Staff Report & Recommendation

Historic Preservation Board

SUBJECT: HPB23-0575, **100 Block of Lincoln Road Right-of-Way and 1 Lincoln Road.**

The applicant has submitted plans entitled “Lincoln Road – 100 Block”, as prepared by Kobi Karp Architecture and Interior Design, Inc., dated July 6, 2023.

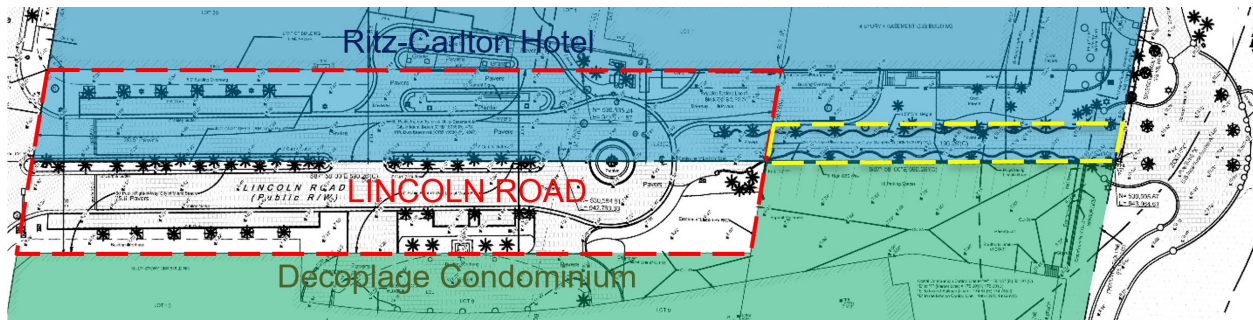
Staff would preface this analysis by noting the unique ownership conditions of the portion of Lincoln Road east of Collins Avenue. As can be seen in the diagram below, the northern half of what is recognized as Lincoln Road (red) is actually part of the Ritz-Carlton Hotel property (blue). Additionally, the northeastern corner of the Decoplage Condominium (green) property extends north to meet the Ritz-Carton property. In order to provide access to the Beachwalk, the City has a 20'-0" wide pedestrian access agreement (yellow) within the southwestern corner of the property.

The subject application is limited to improvements to Lincoln Road (including the portion owned by the Ritz-Carlton and the pedestrian easement area (the areas outlined in red and yellow). Improvements include the reconfiguration of the roadway and sidewalks, the introduction of decorative paving and enhanced landscaping. Additionally, the applicant is proposing to modify the Ritz-Carlton Hotel drop off area including the widening of the pedestrian walkway along this portion of the building and the introduction of a new driveway and loading area configuration. Staff would note that as part of a separate application (HPB23-0574), the application is also proposing the introduction of a new porte-cochere to provide protection for the proposed drop off area.
